SERVICE BULLETIN

NUMBER: SB 500-27-001, REV B
MODEL: ECLIPSE EA500
SUBJECT: ELEVATOR HINGE COVER INSPECTION / MODIFICATION

This Service Bulletin (SB) inspects the existing elevator trim covers and replaces or reworks, if necessary, the existing elevator hinge covers to conform to type design.

**Slot Width Measurements of Elevator Hinge Covers, View Looking Down
 Figure 1 (Sheet 1 of 2)**

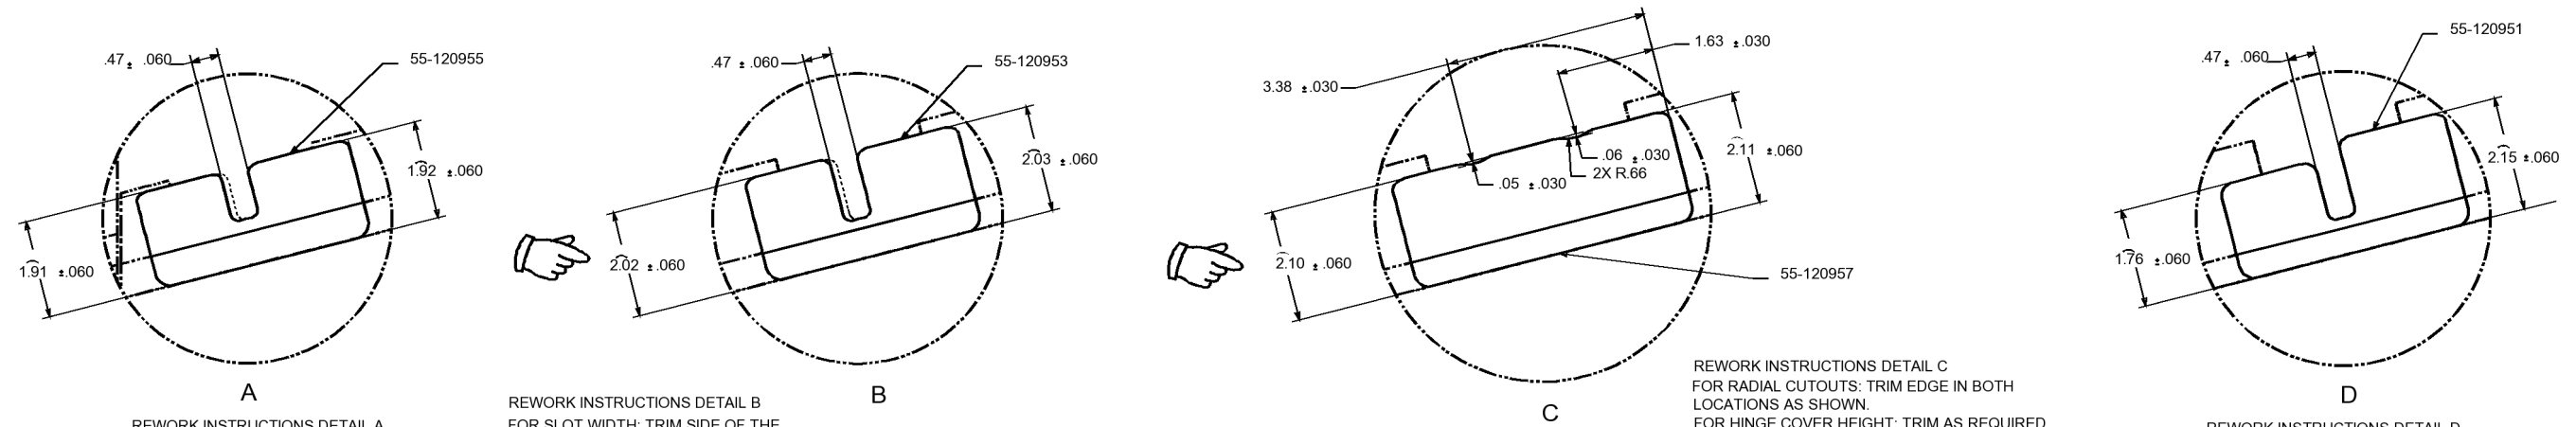
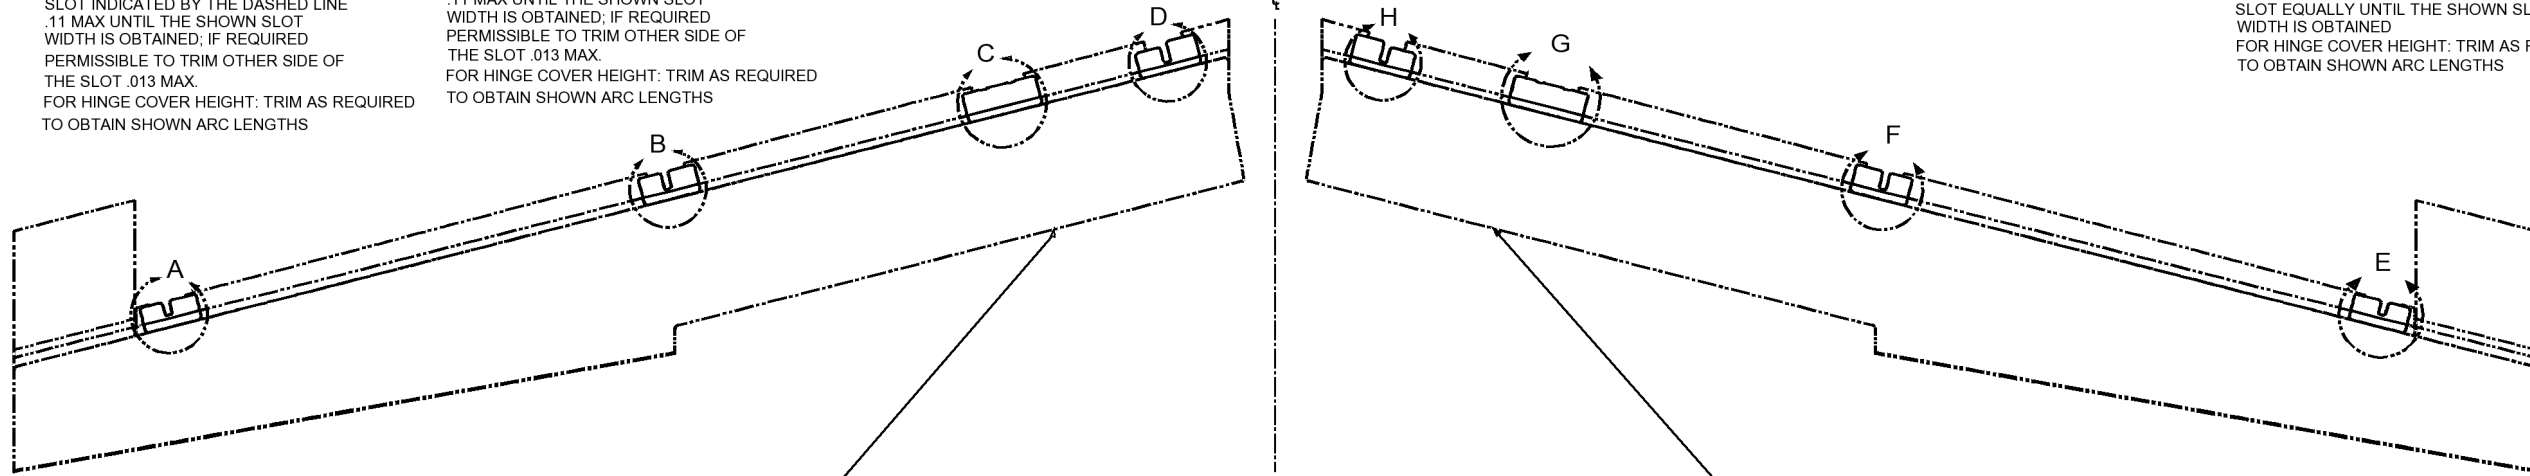
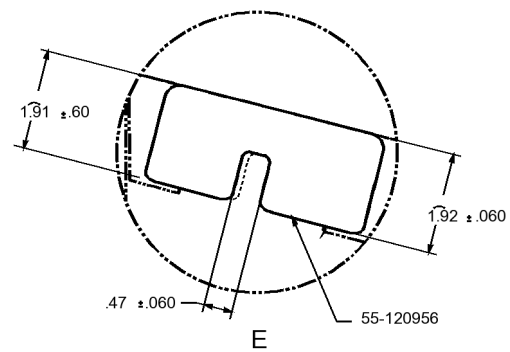
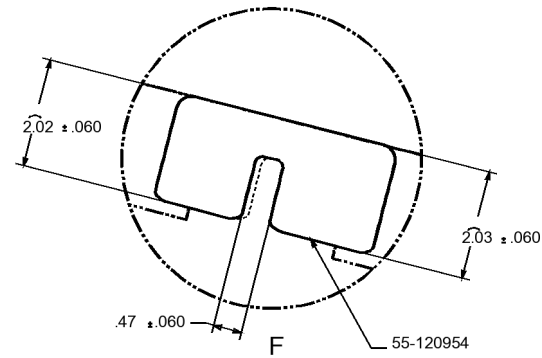
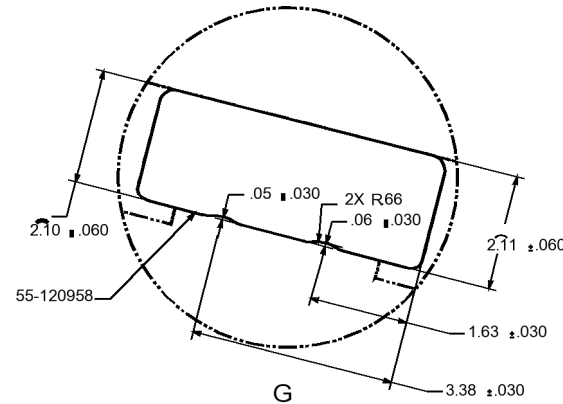
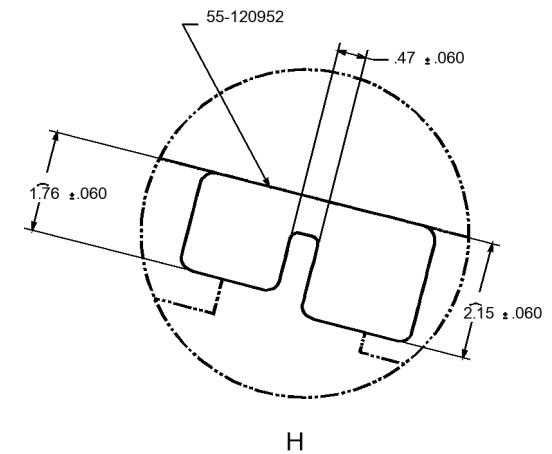
REWORK INSTRUCTIONS DETAIL A
 FOR SLOT WIDTH: TRIM SIDE OF THE SLOT INDICATED BY THE DASHED LINE .11 MAX UNTIL THE SHOWN SLOT WIDTH IS OBTAINED; IF REQUIRED PERMISSIBLE TO TRIM OTHER SIDE OF THE SLOT .013 MAX.
 FOR HINGE COVER HEIGHT: TRIM AS REQUIRED TO OBTAIN SHOWN ARC LENGTHS

REWORK INSTRUCTIONS DETAIL B
 FOR SLOT WIDTH: TRIM SIDE OF THE SLOT INDICATED BY THE DASHED LINE .11 MAX UNTIL THE SHOWN SLOT WIDTH IS OBTAINED; IF REQUIRED PERMISSIBLE TO TRIM OTHER SIDE OF THE SLOT .013 MAX.
 FOR HINGE COVER HEIGHT: TRIM AS REQUIRED TO OBTAIN SHOWN ARC LENGTHS

REWORK INSTRUCTIONS DETAIL C
 FOR RADIAL CUTOUTS: TRIM EDGE IN BOTH LOCATIONS AS SHOWN.
 FOR HINGE COVER HEIGHT: TRIM AS REQUIRED TO OBTAIN SHOWN ARC LENGTHS

REWORK INSTRUCTIONS DETAIL D
 FOR SLOT WIDTH: TRIM EACH SIDE OF THE SLOT EQUALLY UNTIL THE SHOWN SLOT WIDTH IS OBTAINED
 FOR HINGE COVER HEIGHT: TRIM AS REQUIRED TO OBTAIN SHOWN ARC LENGTHS

(55-111277, LH ELEVATOR ASSY)
 *FOR ALL TRIMMED AREAS, TOUCH UP CHEMICAL CONVERSION COAT PER EAC P1009 AND PAINT AND PRIME PER EAC P1024

(55-111344, RH ELEVATOR ASSY)
 *FOR ALL TRIMMED AREAS, TOUCH UP CHEMICAL CONVERSION COAT PER EAC P1009 AND PAINT AND PRIME PER EAC P1024

REWORK INSTRUCTIONS DETAIL E
 FOR SLOT WIDTH: TRIM SIDE OF THE SLOT INDICATED BY THE DASHED LINE .11 MAX UNTIL THE SHOWN SLOT WIDTH IS OBTAINED; IF REQUIRED PERMISSIBLE TO TRIM OTHER SIDE OF THE SLOT .013 MAX.
 FOR HINGE COVER HEIGHT: TRIM AS REQUIRED TO OBTAIN SHOWN ARC LENGTHS

REWORK INSTRUCTIONS DETAIL F
 FOR SLOT WIDTH: TRIM SIDE OF THE SLOT INDICATED BY THE DASHED LINE .11 MAX UNTIL THE SHOWN SLOT WIDTH IS OBTAINED; IF REQUIRED PERMISSIBLE TO TRIM OTHER SIDE OF THE SLOT .013 MAX.
 FOR HINGE COVER HEIGHT: TRIM AS REQUIRED TO OBTAIN SHOWN ARC LENGTHS

REWORK INSTRUCTIONS DETAIL G
 FOR RADIAL CUTOUTS: TRIM EDGE IN BOTH LOCATIONS AS SHOWN.
 FOR HINGE COVER HEIGHT: TRIM AS REQUIRED TO OBTAIN SHOWN ARC LENGTHS

REWORK INSTRUCTIONS DETAIL H
 FOR SLOT WIDTH: TRIM EACH SIDE OF THE SLOT EQUALLY UNTIL THE SHOWN SLOT WIDTH IS OBTAINED
 FOR HINGE COVER HEIGHT: TRIM AS REQUIRED TO OBTAIN SHOWN ARC LENGTHS

Slot Width Measurements of Elevator Hinge Covers, View Looking Up
 Figure 1 (Sheet 2 of 2)

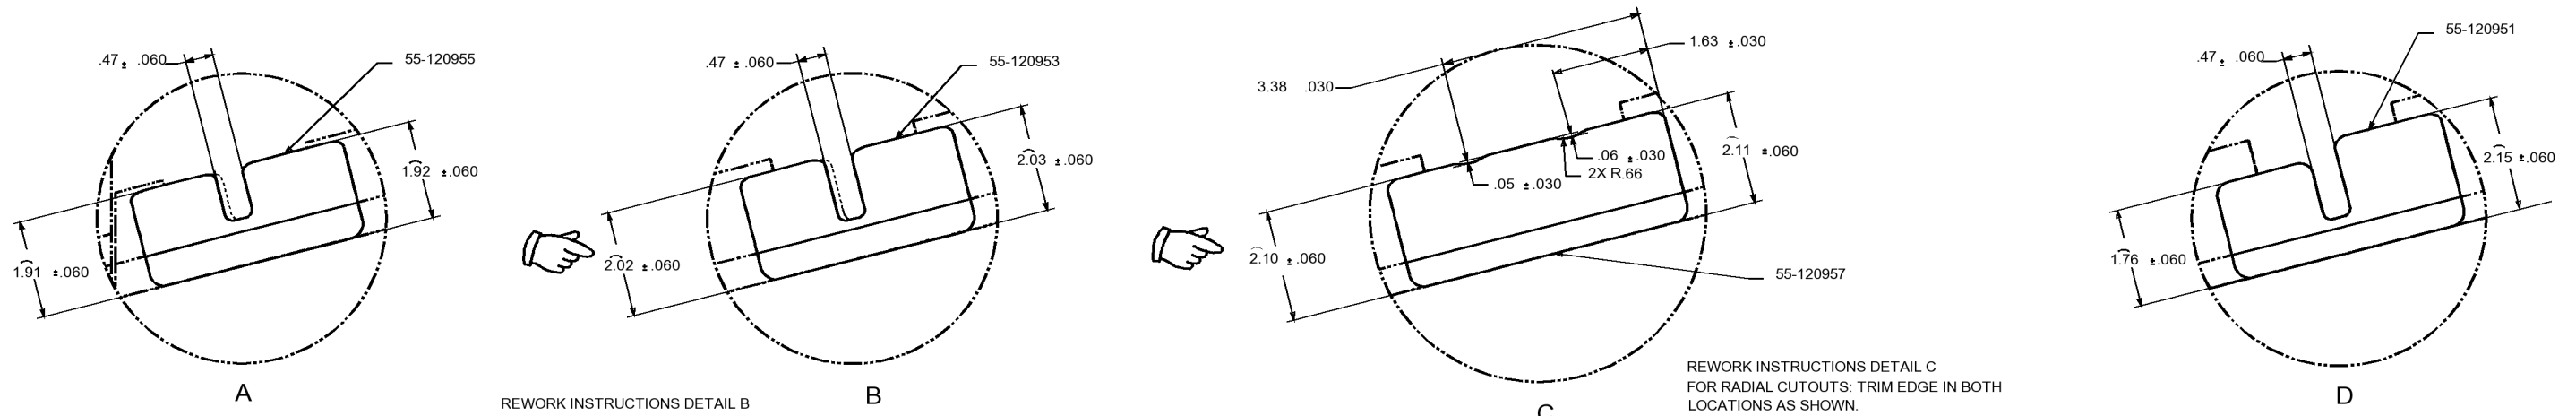
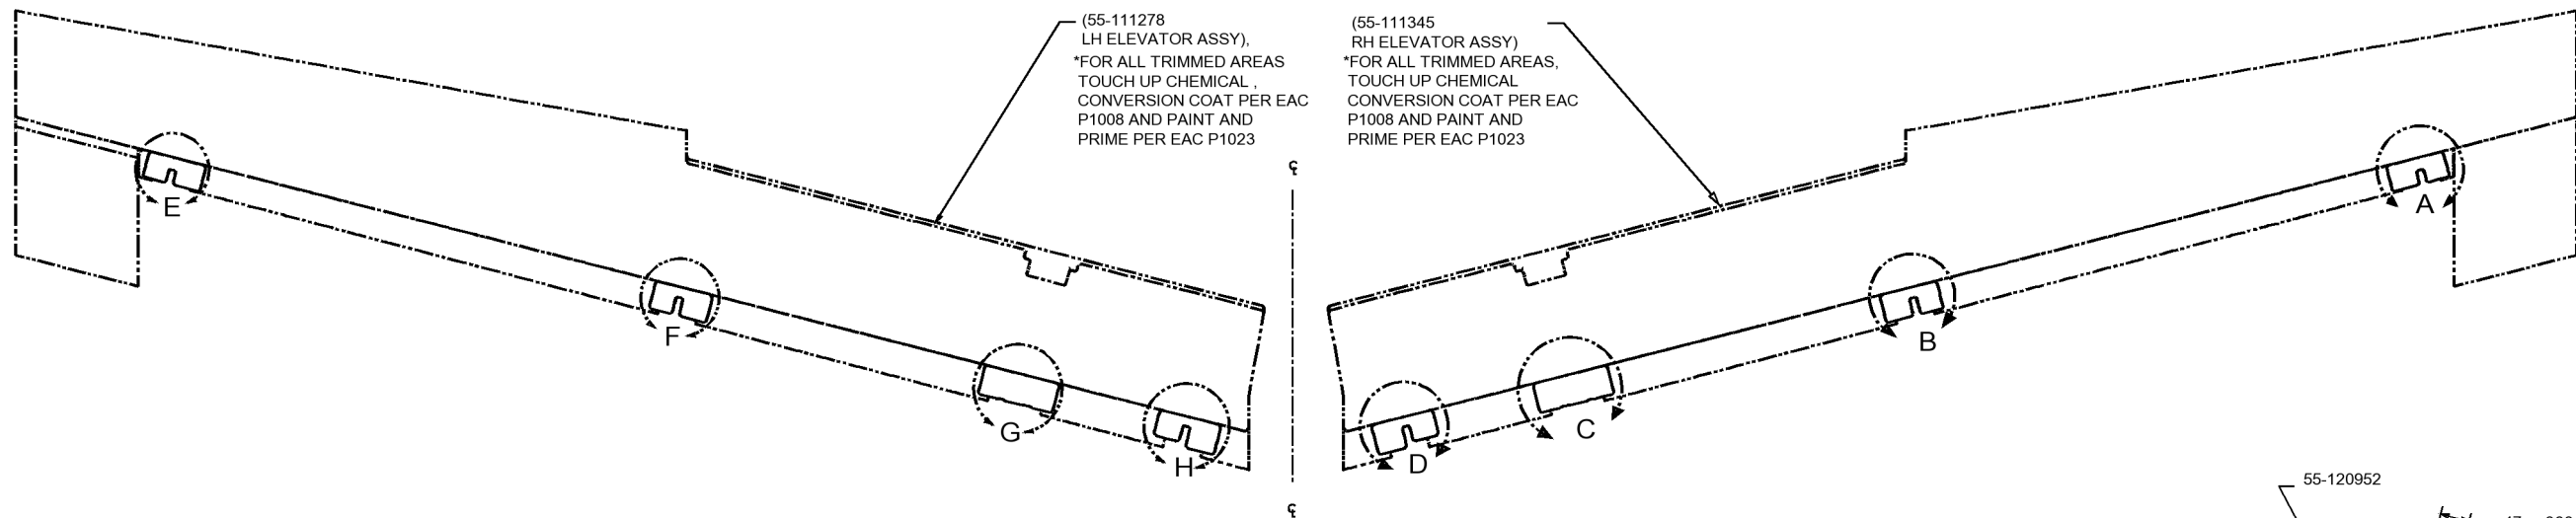
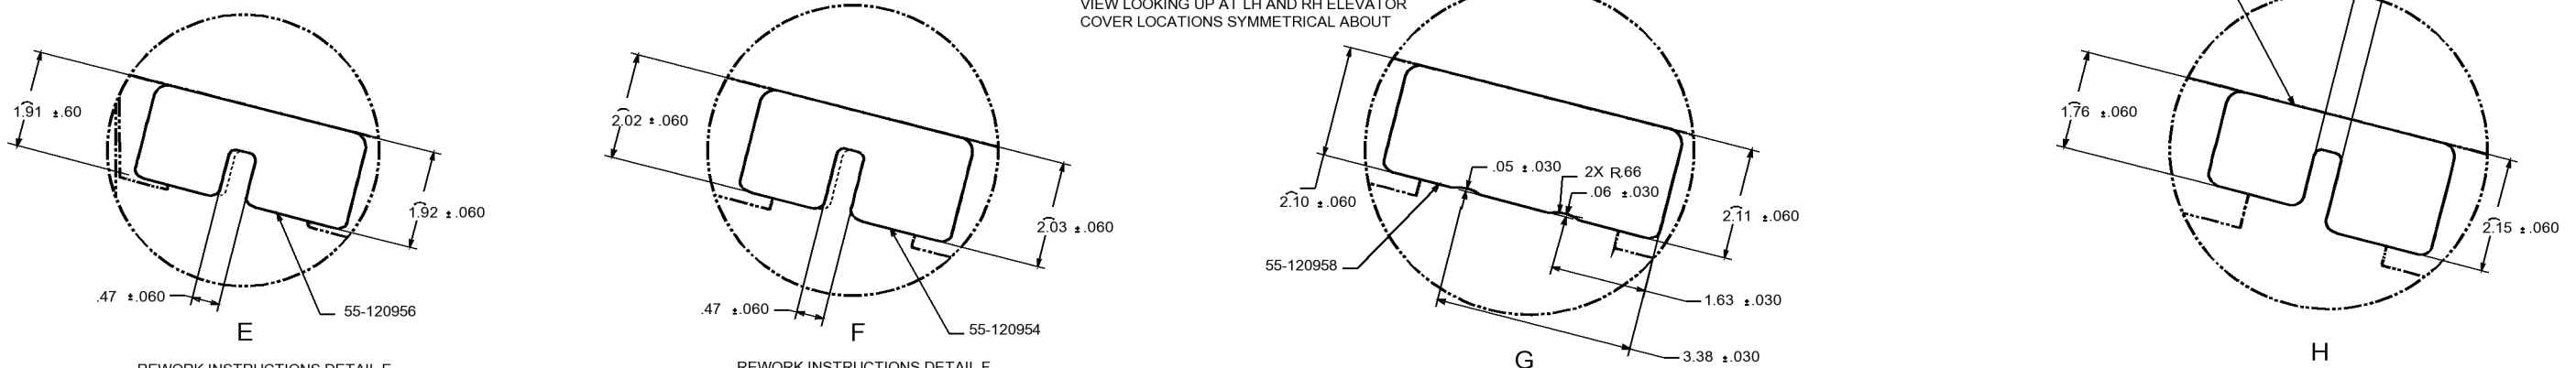
REWORK INSTRUCTIONS DETAIL A
 FOR SLOT WIDTH: TRIM SIDE OF THE SLOT INDICATED BY THE DASHED LINE .11 MAX UNTIL THE SHOWN SLOT WIDTH IS OBTAINED; IF REQUIRED PERMISSIBLE TO TRIM OTHER SIDE OF THE SLOT .013 MAX.
 FOR HINGE COVER HEIGHT: TRIM AS REQUIRED TO OBTAIN SHOWN ARC LENGTHS

REWORK INSTRUCTIONS DETAIL B
 FOR SLOT WIDTH: TRIM SIDE OF THE SLOT INDICATED BY THE DASHED LINE .11 MAX UNTIL THE SHOWN SLOT WIDTH IS OBTAINED; IF REQUIRED PERMISSIBLE TO TRIM OTHER SIDE OF THE SLOT .013 MAX.
 FOR HINGE COVER HEIGHT: TRIM AS REQUIRED TO OBTAIN SHOWN ARC LENGTHS

REWORK INSTRUCTIONS DETAIL C
 FOR RADIAL CUTOUTS: TRIM EDGE IN BOTH LOCATIONS AS SHOWN.
 FOR HINGE COVER HEIGHT: TRIM AS REQUIRED TO OBTAIN SHOWN ARC LENGTHS

REWORK INSTRUCTIONS DETAIL D
 FOR SLOT WIDTH: TRIM EACH SIDE OF THE SLOT EQUALLY UNTIL THE SHOWN SLOT WIDTH IS OBTAINED
 FOR HINGE COVER HEIGHT: TRIM AS REQUIRED TO OBTAIN SHOWN ARC LENGTHS

REWORK INSTRUCTIONS DETAIL E
 FOR SLOT WIDTH: TRIM SIDE OF THE SLOT INDICATED BY THE DASHED LINE .11 MAX UNTIL THE SHOWN SLOT WIDTH IS OBTAINED; IF REQUIRED PERMISSIBLE TO TRIM OTHER SIDE OF THE SLOT .013 MAX.
 FOR HINGE COVER HEIGHT: TRIM AS REQUIRED TO OBTAIN SHOWN ARC LENGTHS

REWORK INSTRUCTIONS DETAIL F
 FOR SLOT WIDTH: TRIM SIDE OF THE SLOT INDICATED BY THE DASHED LINE .11 MAX UNTIL THE SHOWN SLOT WIDTH IS OBTAINED; IF REQUIRED PERMISSIBLE TO TRIM OTHER SIDE OF THE SLOT .013 MAX.
 FOR HINGE COVER HEIGHT: TRIM AS REQUIRED TO OBTAIN SHOWN ARC LENGTHS

REWORK INSTRUCTIONS DETAIL G
 FOR RADIAL CUTOUTS: TRIM EDGE IN BOTH LOCATIONS AS SHOWN.
 FOR HINGE COVER HEIGHT: TRIM AS REQUIRED TO OBTAIN SHOWN ARC LENGTHS

REWORK INSTRUCTIONS DETAIL H
 FOR SLOT WIDTH: TRIM EACH SIDE OF THE SLOT EQUALLY UNTIL THE SHOWN SLOT WIDTH IS OBTAINED
 FOR HINGE COVER HEIGHT: TRIM AS REQUIRED TO OBTAIN SHOWN ARC LENGTHS
